CONTRACT CHANGE ORDER NO. 42
 SHEET X OF XX

EA 0120F1
 E-286

**DETAILS
 TOWER AND SUSPENSION CABLE
 TOWER POWER AND LIGHTING**
 SCALE 1:50

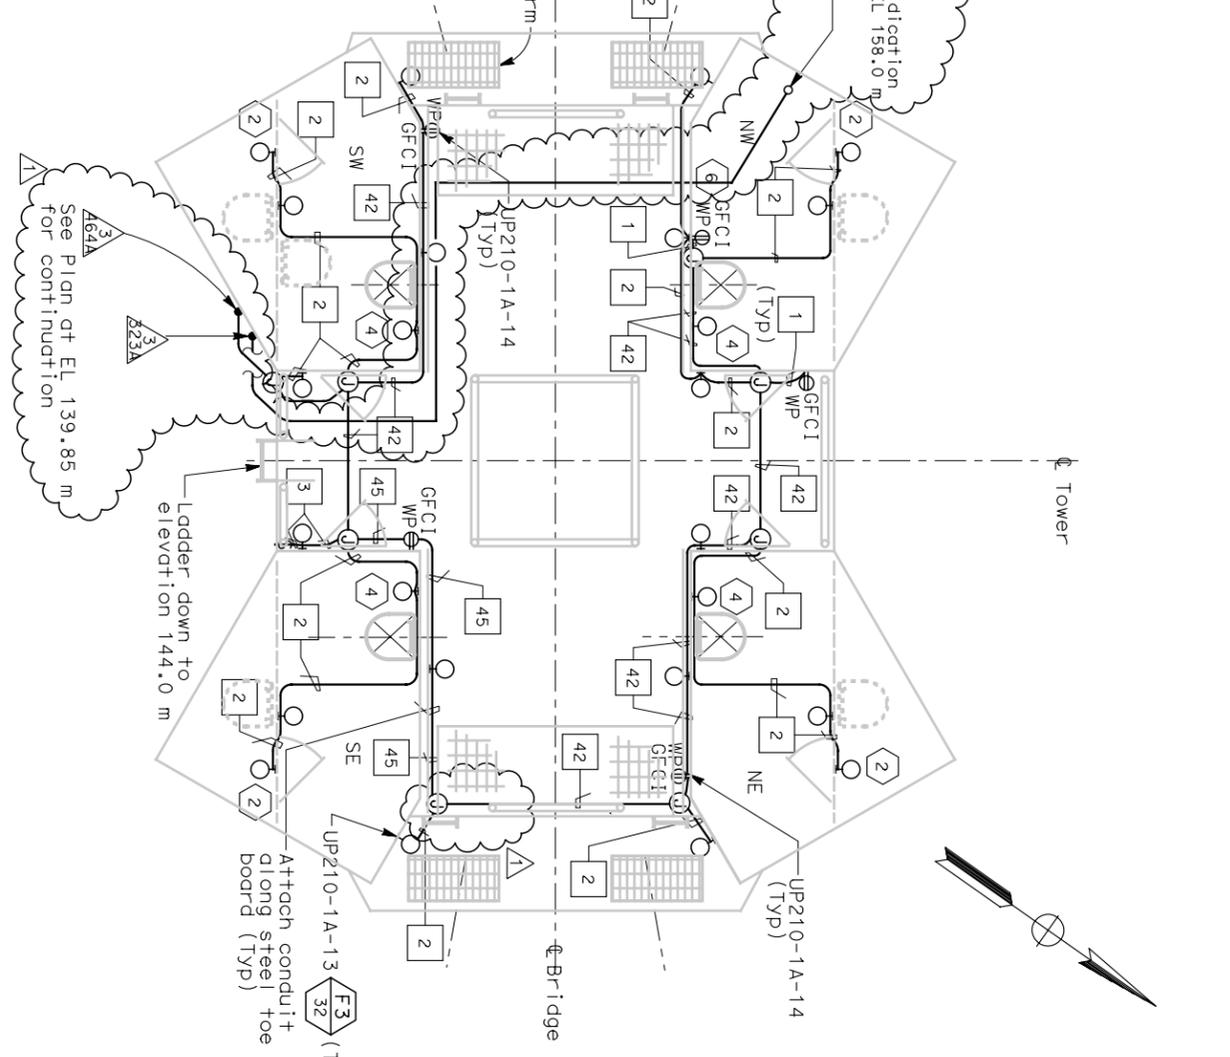
Revision to misc. electric work, revise conduit routing and add cable trays per REI-543.	MP	EL	RR	42
REVISIONS	BY	CK	CCO	
8/6/07				
MARK DATE
